MC68360

Errata and Added Information to

MC68360 Quad Integrated Communication Controller User's Manual Rev 1

January 8, 1998

Figure 6-6A External Components for 4.192MHz

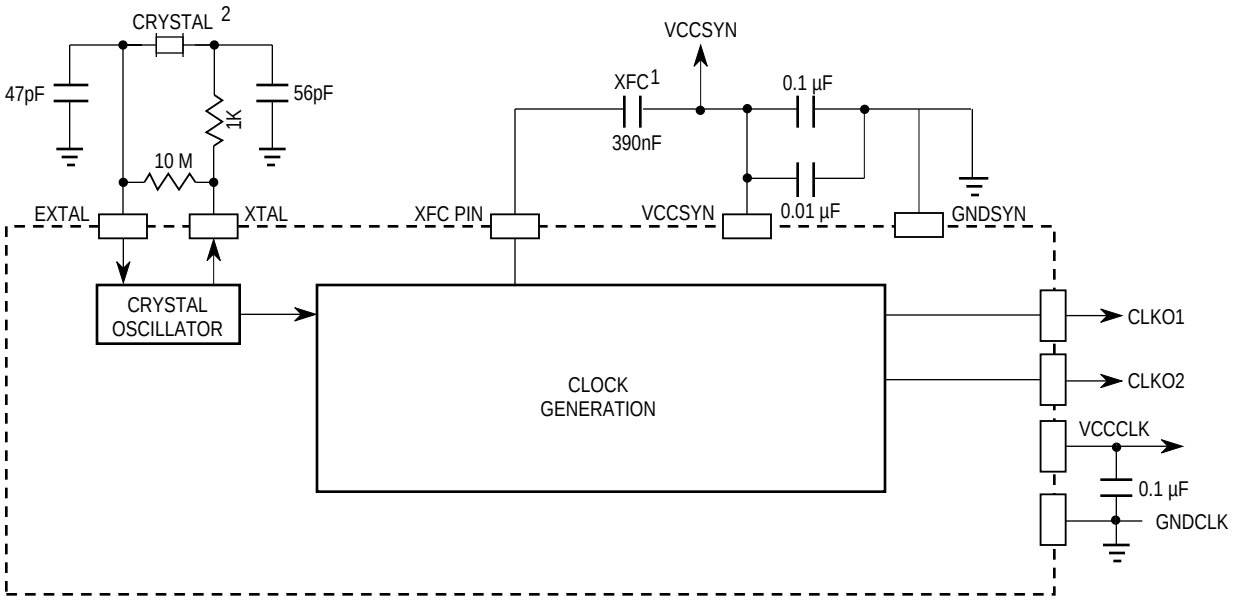
Also on page 6-14 the following figure should be added.

Figure 10-44(b) MC68040/EC040 SRAM Write cycle (TSS40=0, CSNT40=1)

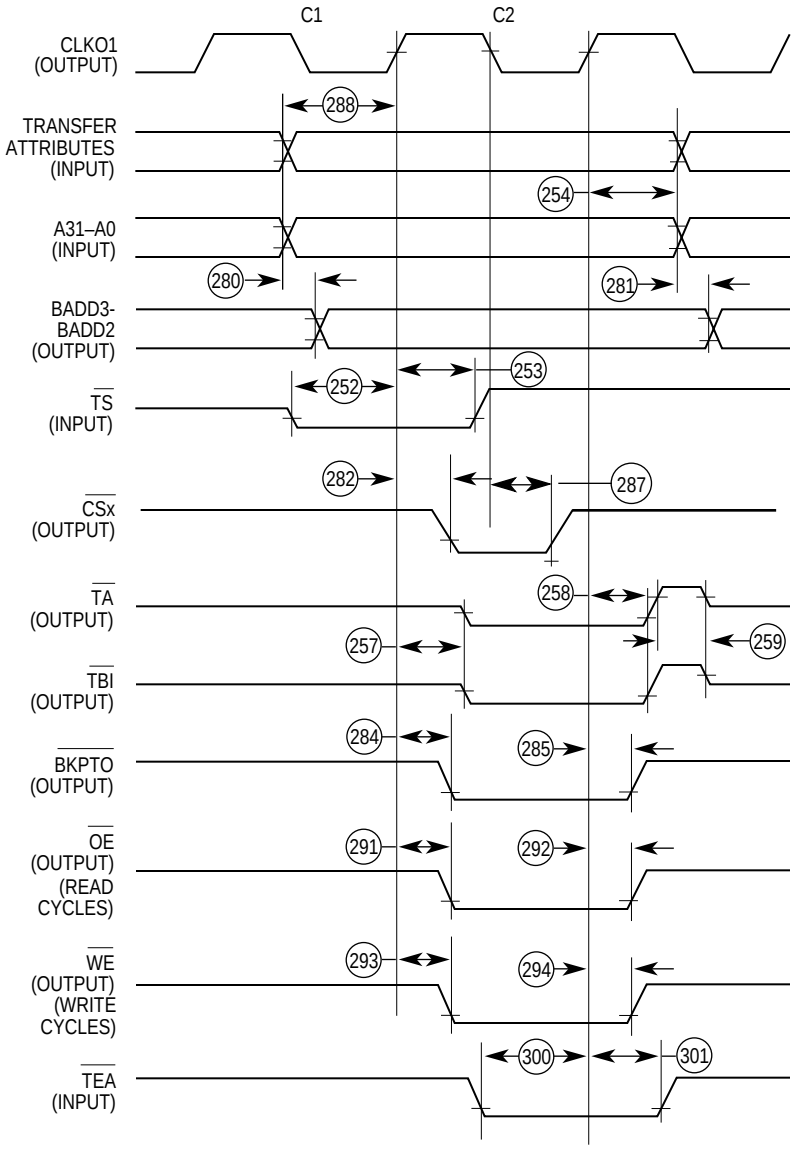
The following figure should be added after figure 10-44(a)

Figure 10-45(b) MC68040/EC040 SRAM Read Cycle (TSS40=1, CSNT40=1)

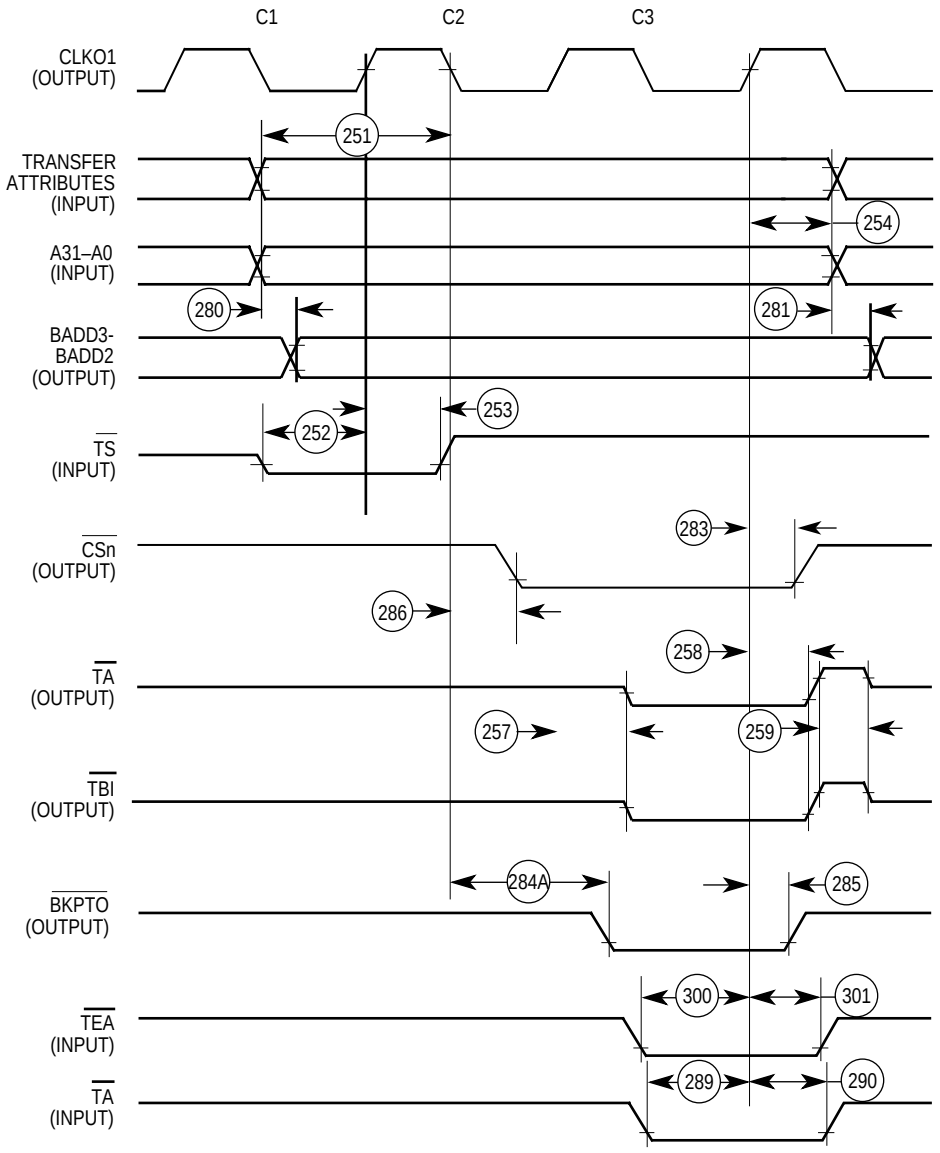
$\overline{OE}$ and $\overline{WE}$ signals are not supported when TSS40 is set to 1.

The following figure should be added below figure 10-45(a)
